MONTGOMERY COUNTY HISTORIC PRESERVATION COMMISSION
STAFF REPORT

Address:	11 East Lenox Street, Chevy Chase	Meeting Date:	3/14/2018
Resource:	Contributing Resource Chevy Chase Village Historic District	Report Date:	3/7/2018
Applicant:	Brit and Kelleen Snider (Luke Olson, Architect)	Public Notice:	2/28/2018
Review:	HAWP	Tax Credit:	N/A
Case Number:	35/13-18D REVISION	Staff:	Michael Kyne
PROPOSAL:	Building addition

PROPOSED FRONT ELEVATION

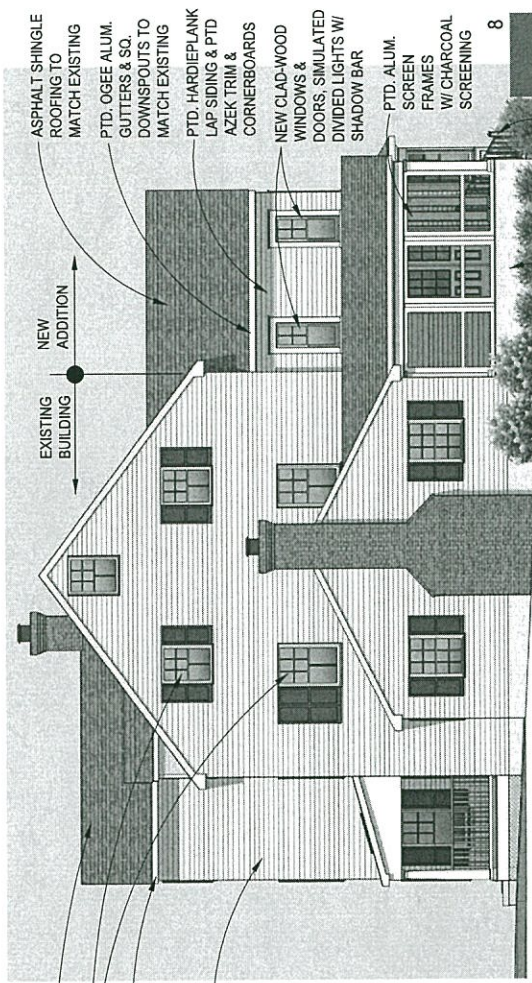
As noted, the applicants' proposal to replace the existing aluminum siding and trim was previously approved at the February 7, 2018 HPC meeting. The applicants now propose to make the following changes to the previously approved trim: the addition of trim in the gable dormers, making them pedimented dormers; enlarging the window head trim; the addition of box eave returns to the cornice trim; and the addition of modillions in the front gable. Per the previous approval, the proposed trim will be constructed from composite materials, such as Azek or fiber cement.

Staff finds that the proposed trim changes are generally compatible with the Colonial Revival-style and with the character of the historic district. Because the subject property has already been extensively altered, it is unlikely that these changes will detract from the character-defining features of the subject property or surrounding streetscape.

- The homeowners would also like to introduce a simple modillion detail to the front gable eave & rake to reference the detail that is shown in the historic photo of the resource.

1. Window details will be provided, with final review and approval delegated to staff.
2. A section drawing of the front gable and modillion details will be provided, with final review and approval delegated to staff.

PROPOSED REVISION

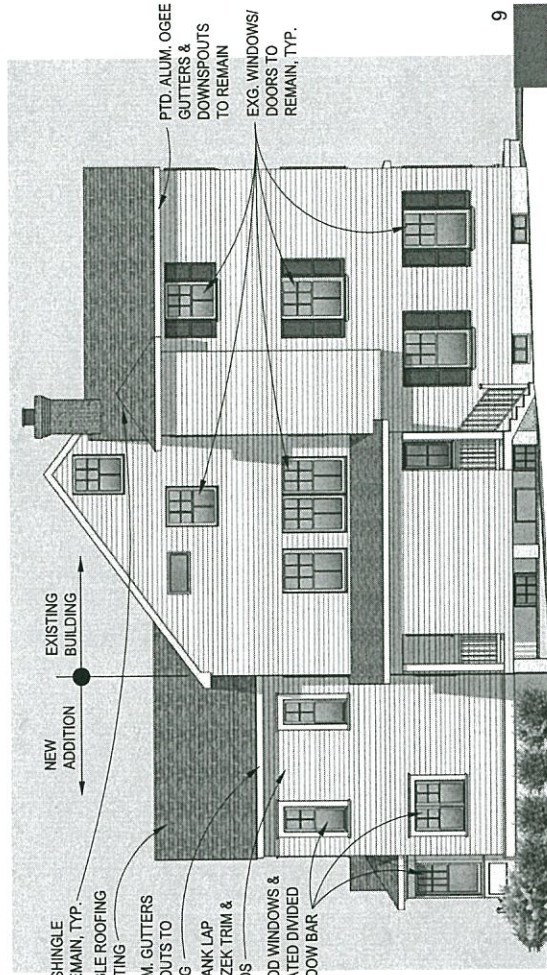
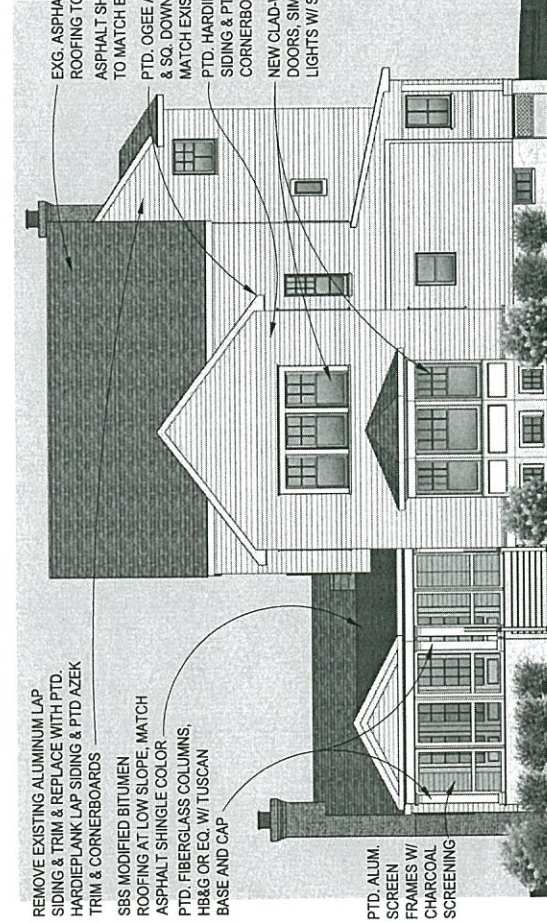
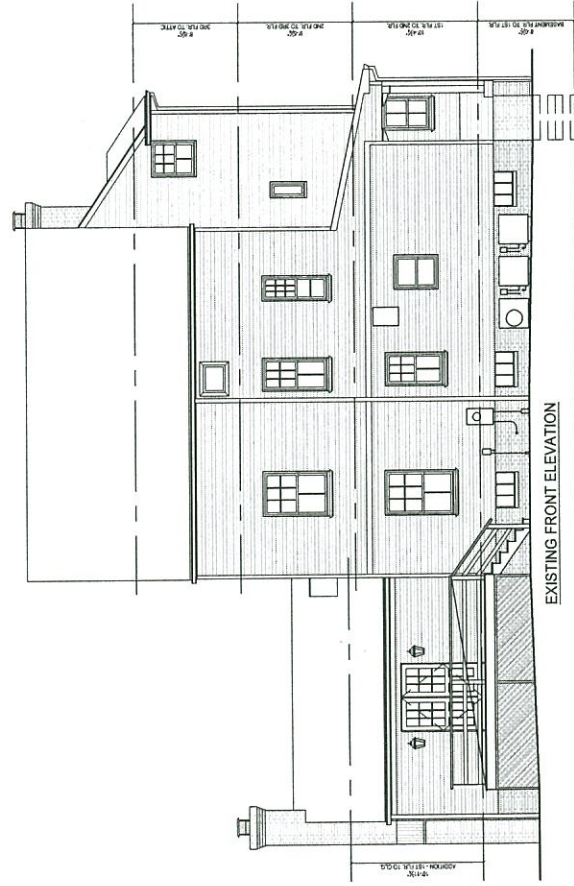
Submitted historic photographs indicate that the existing projecting bay on the left elevation of the historic house is not an original feature, and it was likely added as part of previous alterations, such as the construction of the existing third story addition. The applicants propose to install a new four-over-one double-hung SDL wood window in the projecting bay. The proposed window is generally consistent with the existing six-over-two windows of the historic house and matches the previously approved four-over-one windows in the rear addition.

Because the proposed window will be added to a non-original feature on a secondary elevation, staff finds that this alteration is unlikely to detract from the character-defining features of the subject property or surrounding streetscape. Staff recommends a condition of approval, stipulating that

- add one window to the existing 2nd floor bathroom on the left side elevation bay projection. This window would be marginally visible from the public view and is in a location where the historic resource has been significantly altered

window details will be provided to ensure that the proposed window is consistent with the Commission's requirements (permanently-affixed 7/8" profile exterior and interior muntins with internal spacer bars).
